E. Conway
File No: SP15-011562

TO:	CHAIR AND MEMBERS – PLANNING & ENVIRONMENT COMMITTEE
FROM:	GEORGE KOTSIFAS, P.ENG MANAGING DIRECTOR, DEVELOPMENT & COMPLIANCE SERVICES & CHIEF BUILDING OFFICIAL
SUBJECT:	APPLICATION BY: 1635 RICHMOND (LONDON) CORPORATION RISE REAL ESTATE INC. 1631, 1635, 1639, 1643 AND 1649 RICHMOND STREET PUBLIC SITE PLAN MEETING MAY 19, 2015

Consideration of the Site Plan will result in the construction of a two apartment buildings, each six storeys in height and 18 townhouse units in five blocks.

Site Plan

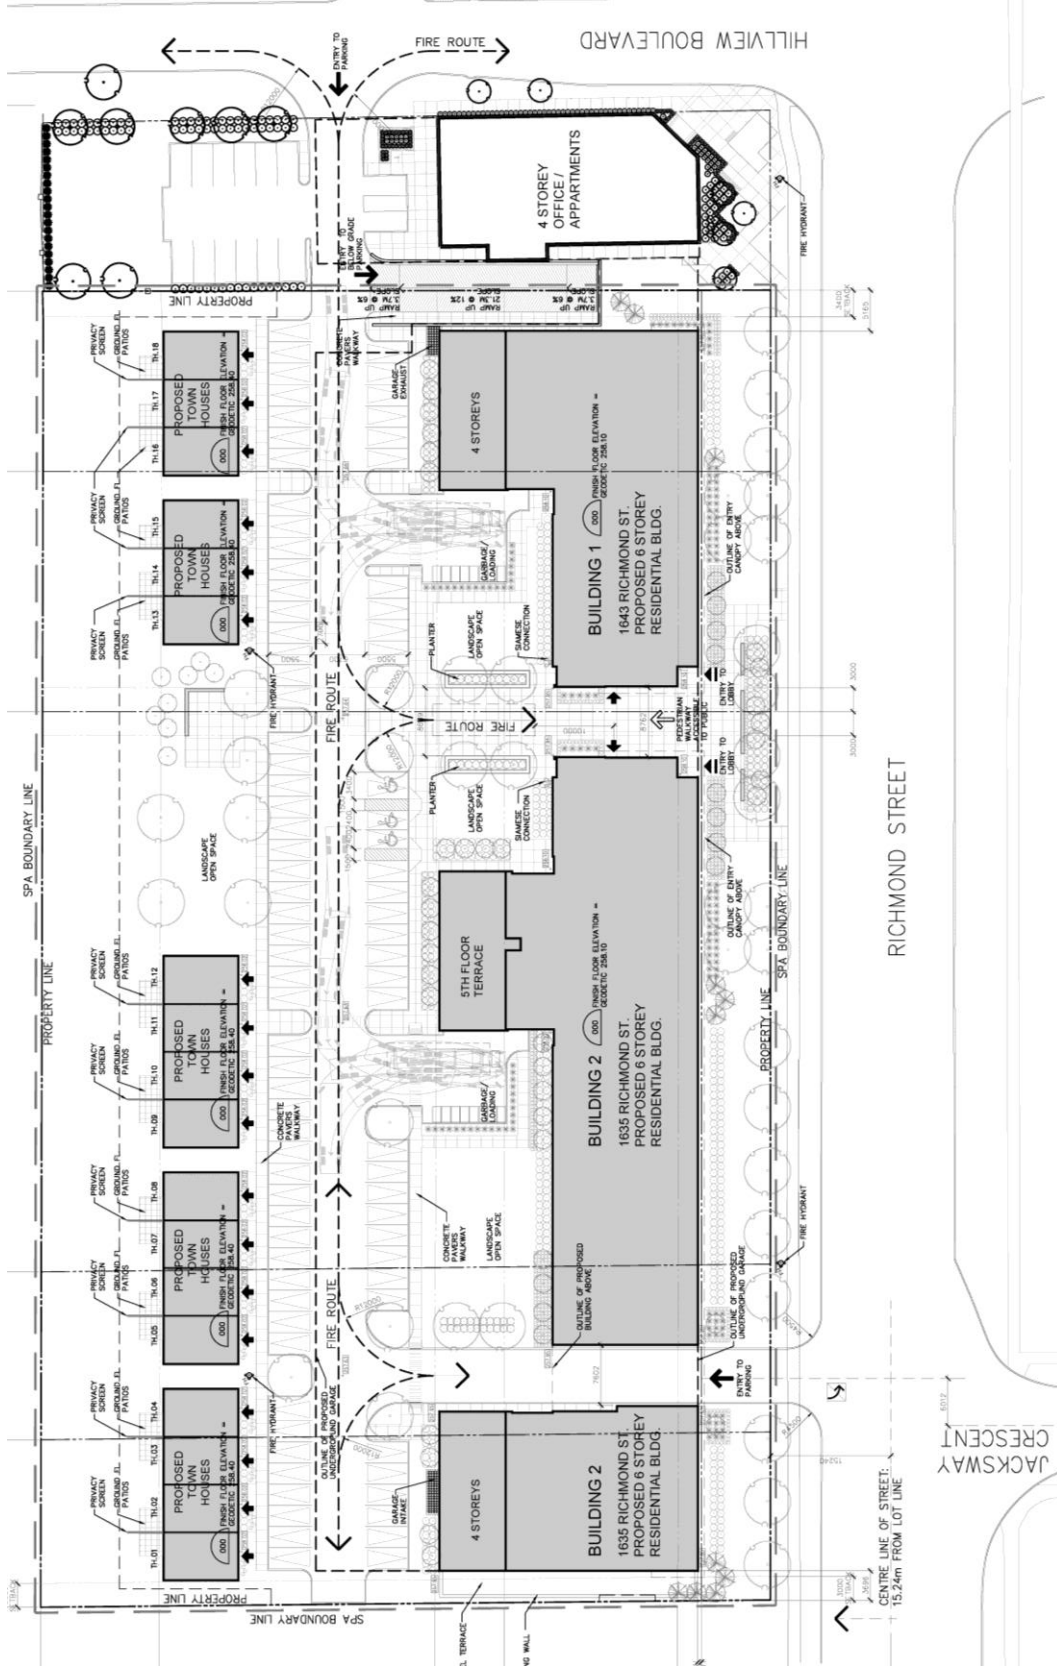
The proposed site plan works well for vehicles but not so well for pedestrians. Residents, especially students heading to or returning from Western University will use the south driveway through Building 2 to get to Richmond Street rather than the more northerly, purpose-designed pedestrian walkway between Buildings 1 and 2. It is recommended that the width of the southerly driveway be reduced to 6 metres allowing for a dedicated walkway through Building 2. Consider a concrete driveway entrance/exit at sidewalk height rather than curb radii to avoid a change in the public sidewalk elevation. A lay-by is justified to facilitate pick-ups and drop-offs on Richmond Street given the extensive site frontage. 148 parking spaces are required; 181 are proposed. A reduction in parking is recommended to improve the internal landscape by allowing for more trees and groundcover especially in front of the townhouses of structure.

The proposed P1 Level ‘terrace’ at the south end of Building 2 is a 4 metre deep hole essentially making its value as a ‘terrace’ questionable. As well, the ‘terrace’ extends beyond the 3 metre setback line resulting in no space for planting at the south property line in contravention of Official Plan policy requiring landscape screening.

As mentioned, there is no room for landscape screening on the south property line adjacent to Building 2. Further to that, the south property line is devoid of planting except where there is existing vegetation in contravention of OP policy requiring landscape screening.

There is space between the proposed townhouses to accommodate planting. This would improve the residential quality of the site. In relation to 2.3 above, removing at least 9 nine parking spaces to accommodate trees and ground cover would result in a better internal residential landscape.

There appears to be no provision for landscape on structure with the exception of the planters beside the pedestrian walkway from Richmond Street. An appropriate soil/growing medium volume to support specified plant material on structure is required.

- Remove elevated terraces overlooking townhouses.

- Revise access location on Richmond to be aligned with Jacksway. The Richmond St access is to be restricted to right in, left in and right out in accordance with Exhibit 2-2 in the Access Management Guideline.

- Provide pedestrian walkways along vehicular access from Richmond by widening the proposed driveway/porticos generally in accordance with the previous concept attached to the amending Zoning by-law. The original concepts provide separate pedestrian entrances parallel with the drive aisle and the volume of the entrance is two stories along Richmond. Include walkways on both sides of the vehicular entrance to provide multiple pedestrian access point into the interior of the site.

- Provide a focal point at the view terminus under the archway opposite from Jacksway Cres by widening the landscape island with ornamental plantings.
- Provide an updated Traffic Impact Assessment. If other external improvements are warranted by the TIA (forthcoming), external work plans will be required. Access to Richmond Street will require the construction of a centre median south of the driveway along Richmond and the inclusion of a ½ pork-chop at the egress of the driveway to prohibit left-outs.

- The access to Hillview (on 1653 Richmond Street) will prohibit left-outs and require the construction of a westbound left turn lane.
- Provide a landscape feature at the terminus of the vehicular entrance on Richmond and provide landscape islands within surface parking areas.

- Relocate external waste collection areas from open areas between townhouses units.
- Road widening dedication along the Richmond St frontage measured 24 m from the centre line of the street. Prepare a reference plan for road widening dedication.
- Remove retaining wall from road allowance.
- Remove some of the parking spaces in the northeast parking area and relocate the retaining wall to provide a pedestrian landing area prior to crossing the ramp to the underground parking area.
- Provide privacy fencing along west property boundary unless specific request from neighbours submitted otherwise.
- Add conifers along west property line where there are gaps in the existing vegetation to aid in buffering existing single family residences to the west.

- Add plant materials on the south side of the southern building and remove basement units. Add temporary privacy fencing along south property line along the rear yard of the single family home “to be removed when property to the south substantially redevelops”.

- Provide privacy fencing along west property unless specific request from neighbours submitted otherwise.
- Easements required for shared used and maintenance of driveway and access.

- Add additional conifers along west property line where gaps in the existing vegetation permit.
- Provide a landscape feature at the terminus of the vehicular entrance on Richmond

- Revise plans to preserve mature trees near the south property line by removing the basement apartments and minimizing grading impacts.

The current proposal does not have the proposed vehicular access aligned with Jacksway Crescent. This driveway must be aligned with Jacksway Crescent to avoid turning conflicts at this intersection. The Traffic Impact Assessment (TIA) previously prepared for this area recommended restricting egress from the site to southbound only but to permit northbound left turns into the site. The location of the access also acts as a visual terminus at the end of Jacksway Cres. The previously endorsed building elevations provide for the two-storey archway as illustrated on Schedule A. This is a main architectural feature within the overall composition of the building and improvements continue to be discussed throughout the review process.

Landscape Plan

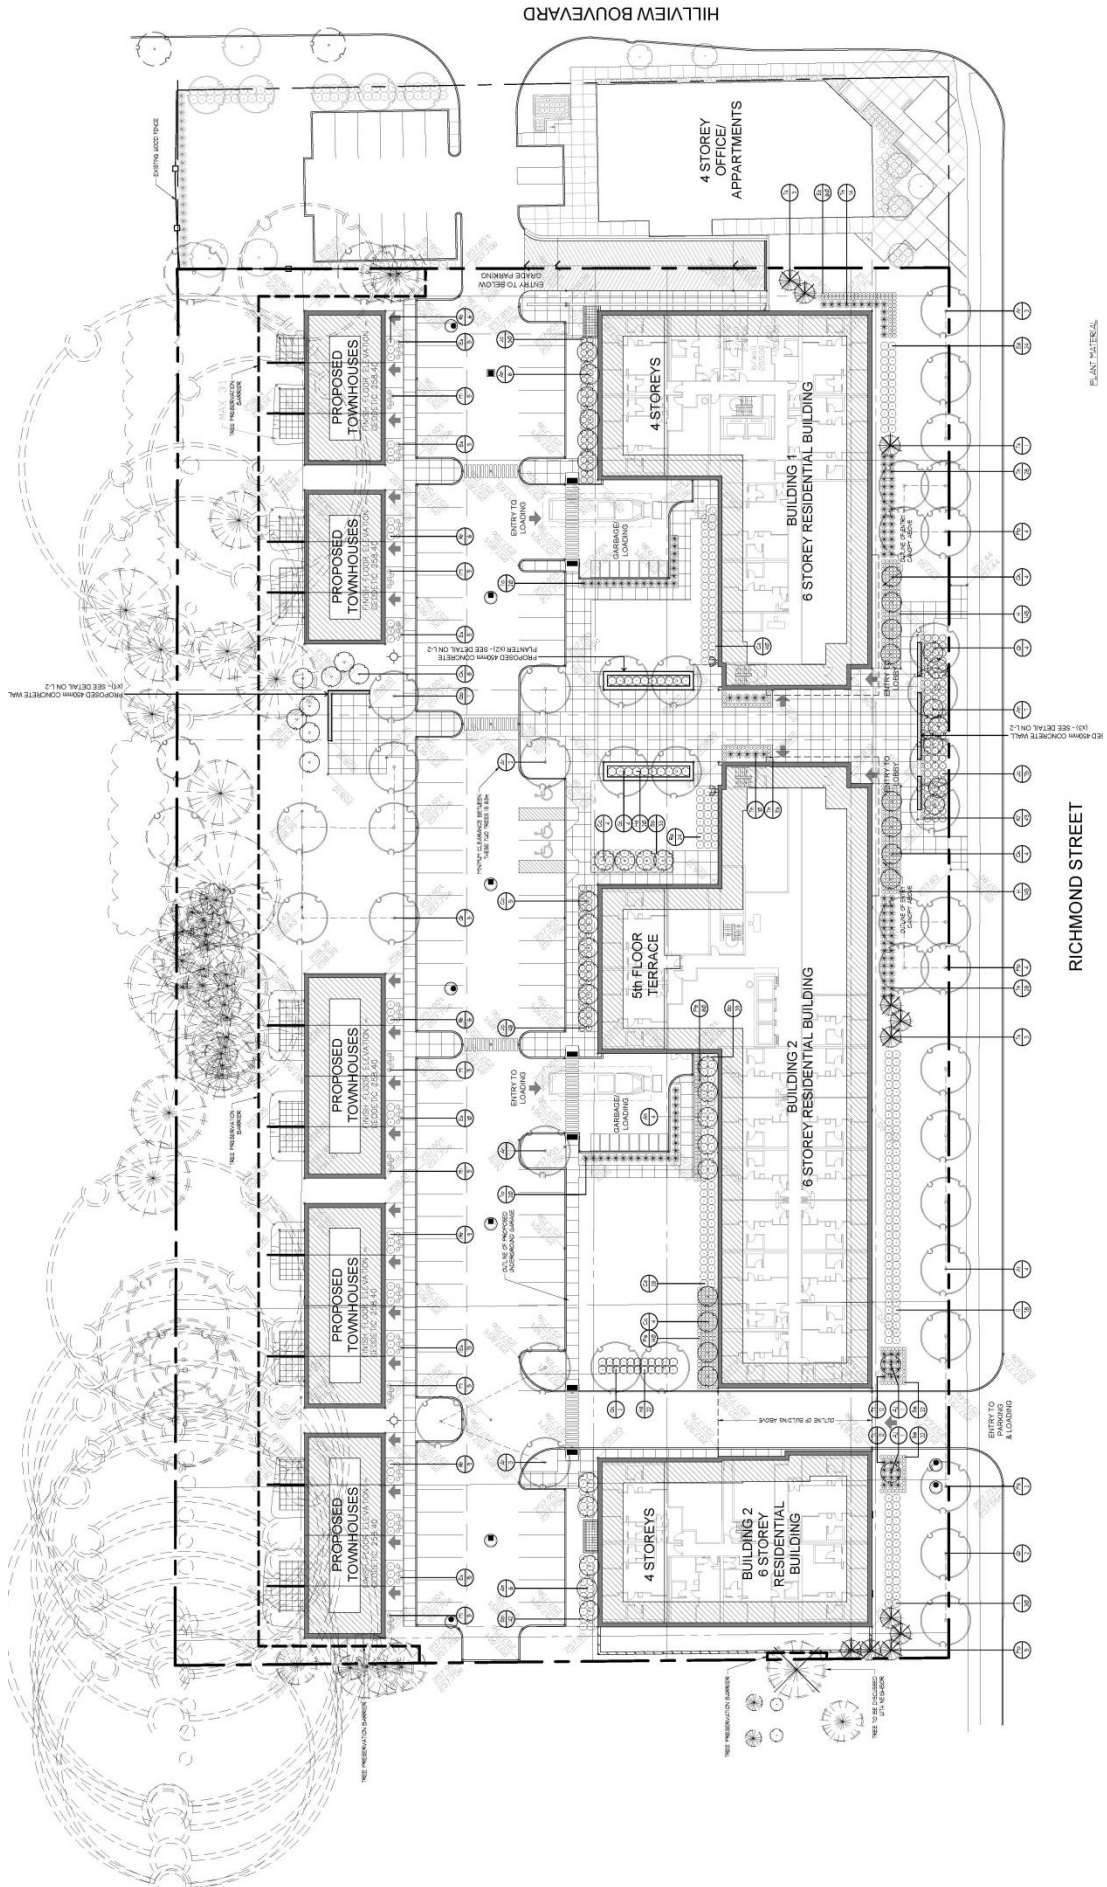
- Provide exterior covered bicycle parking for visitors.
- Tree planting along the boulevard should be brought closer to the road, 1-1.5m behind the sidewalk to create more shade tree presence along the street using only large shade trees (Red Maples being considered medium trees) as there are no overhead hydro lines to impede vertical growth.

East and West Building Elevations - Apartment Buildings

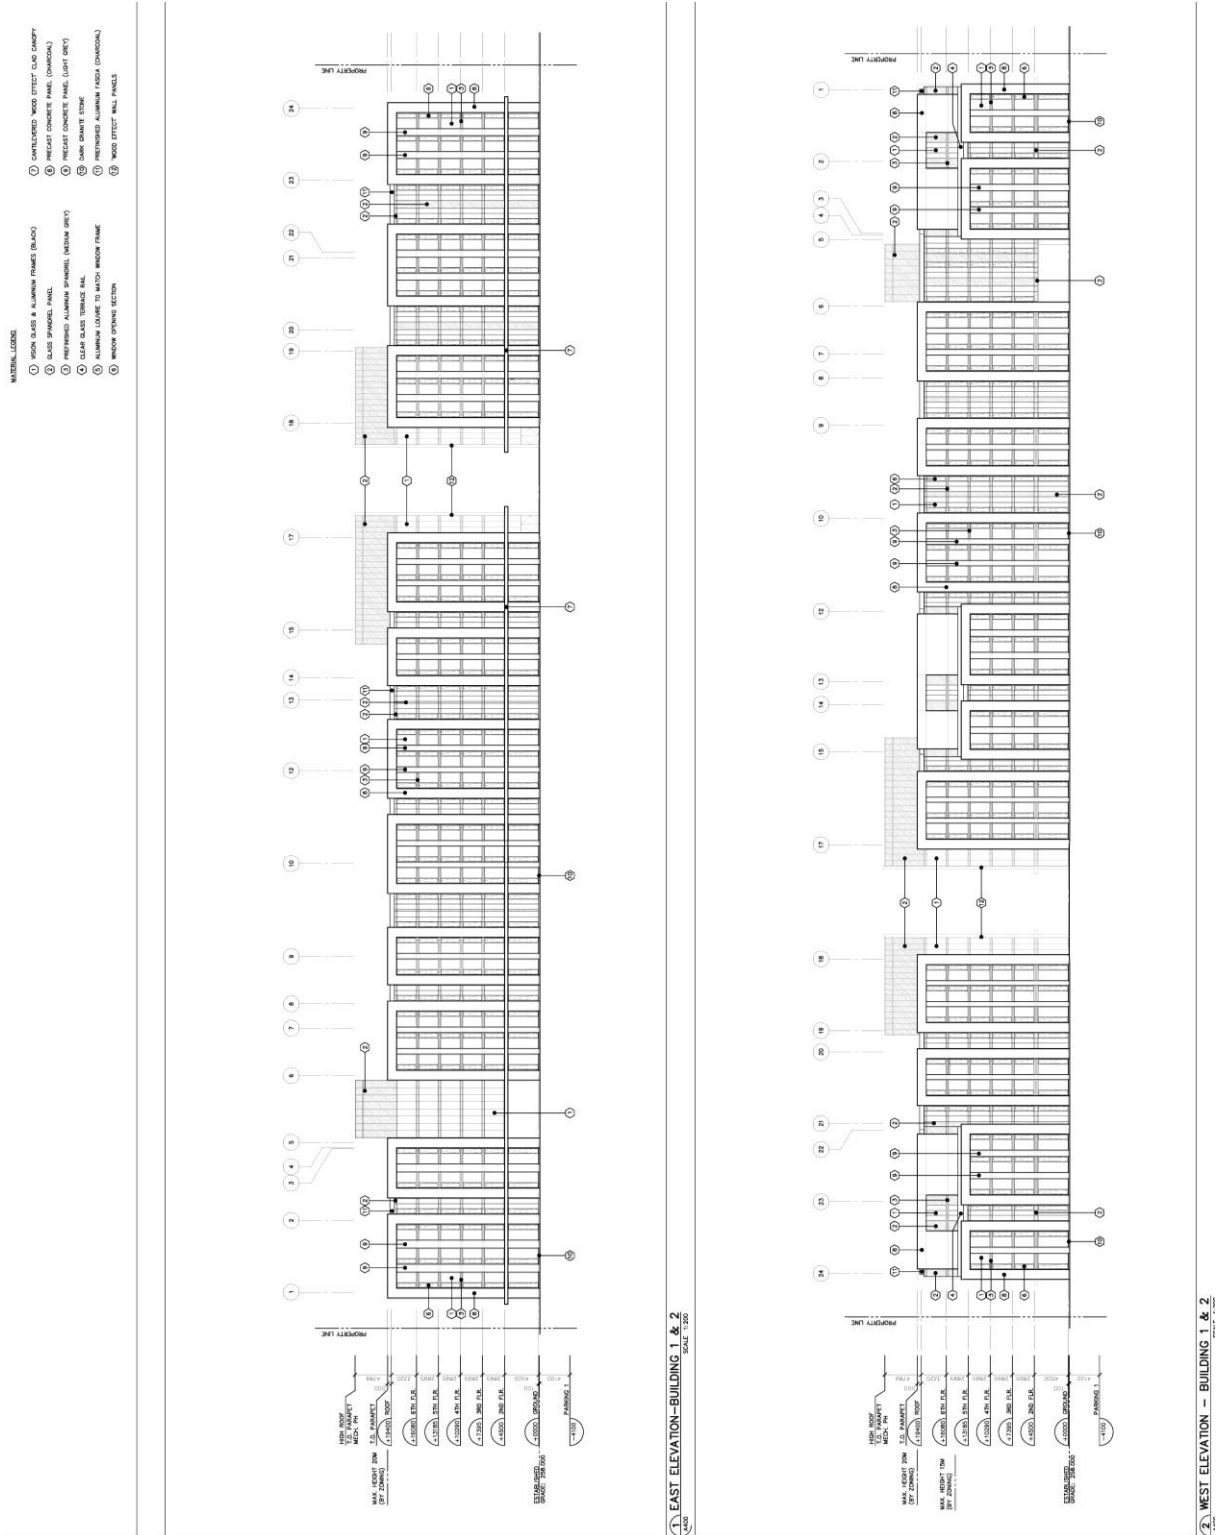
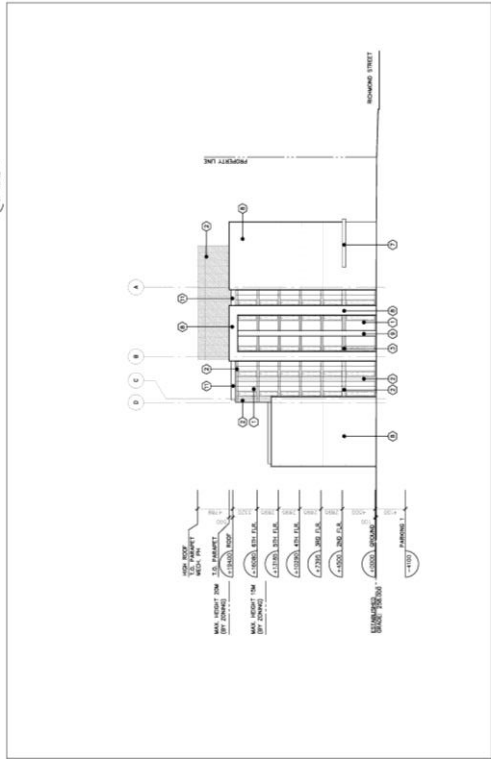
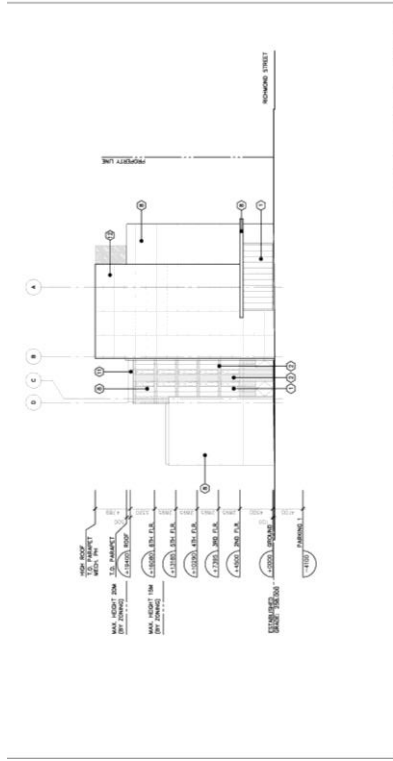
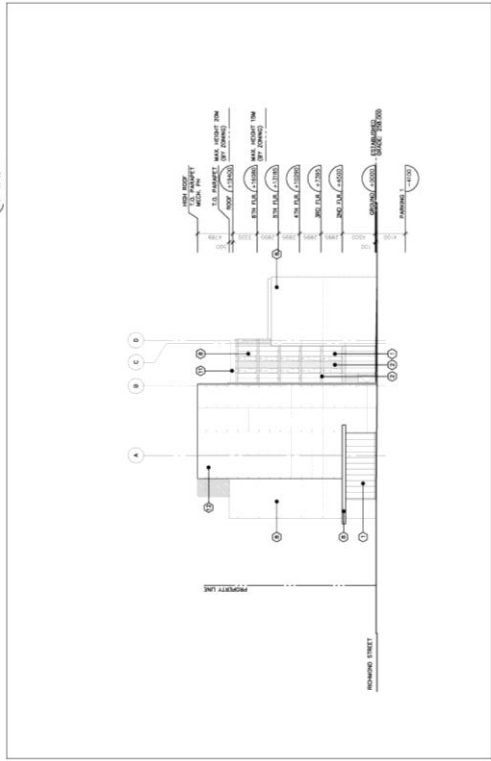
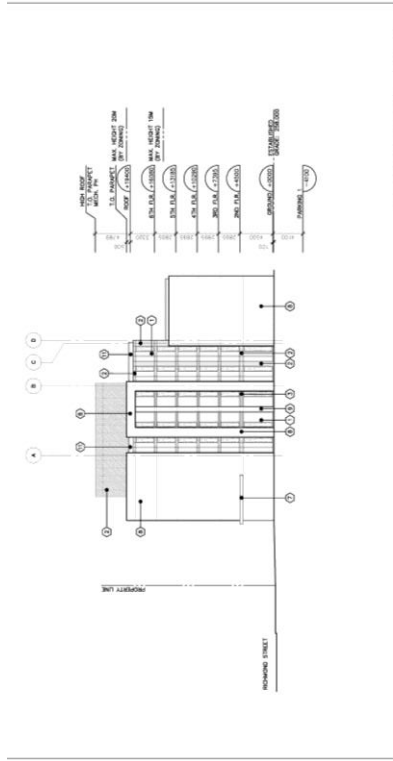
- Provide balconies along Richmond Street frontage.
- Provide ground level entrances to apartment units along Richmond Street and utilize landscaping and hardscaping along the Richmond St. frontage and in between the buildings to provide a pedestrian oriented streetscape that is urban in character.

- The building is to have a residential character and include brick and stone masonry.
- Incorporate recessed balconies into the east elevation of the building to break up the long flat facade and add to the residential character.

The current contemporary proposal is architecturally a very different building than what was previously endorsed by Council. Staff will continue to work with the applicant to achieve a revised building design that is more consistent with Schedule A (which was attached to the Zoning By-law from the Council Resolution dated January 28, 2014).

The applicant has expressed concerns over the number of ground level entrances required along Richmond Street. They have also expressed opposition to providing balconies along Richmond Street. The absence of both elements detracts from the residential design of the building and is generally unsupportable. Staff look forward working with the applicant to achieve a building design that is more consistent with the previous concept reviewed and endorsed by Council through the Zoning By-law amendment and Official Plan amendment process.

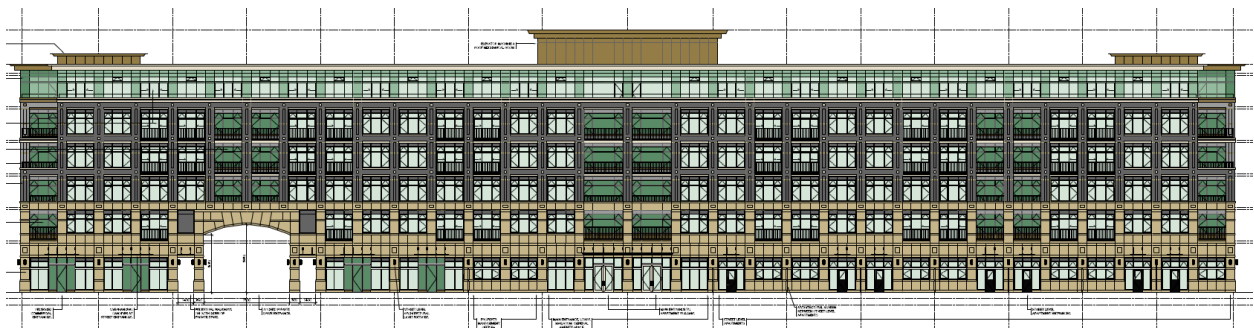
- Development on these properties is subject to the *Richmond Street - Old Masonville Master Plan and Urban Design Guidelines* as well as a Council resolution dated January 11, 2012 stating that the building should be consistent with the following elevation.

- Provide multiple entrances on the ground level of the east facade with direct access to the public sidewalk.
- Differentiate the base of the building with material and architectural change, canopies and higher proportions of glazing on common area portions.
- The vehicular entrance opposite Jacksway Cres should act as a focal point by incorporating architectural detail and being 2 stories in height.

1643, 1649, Richmond Street

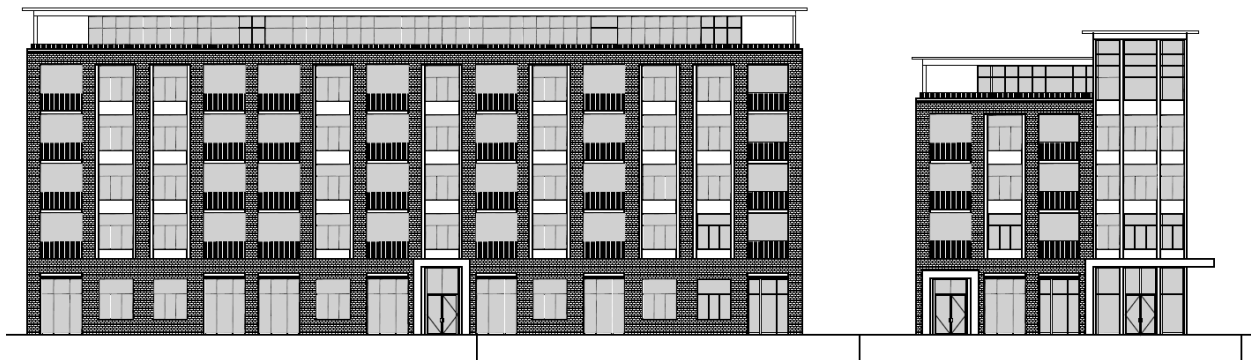
- Development on these properties is subject to the *Richmond Street - Old Masonville Master Plan and Urban Design Guidelines* as well as a Council resolution dated October 15, 2014 stating that the building should be consistent with the following conceptual elevation.

- The massing, proportions and architectural style of the building should complement and be compatible with the corner building at 1653 Richmond St.
- The building is to have a residential character and include brick masonry.
- Incorporate recessed balconies into the east elevation of the building to break up the long flat facade and add to the residential character.
- Provide multiple entrances on the ground level of the east facade with direct access to the public sidewalk.
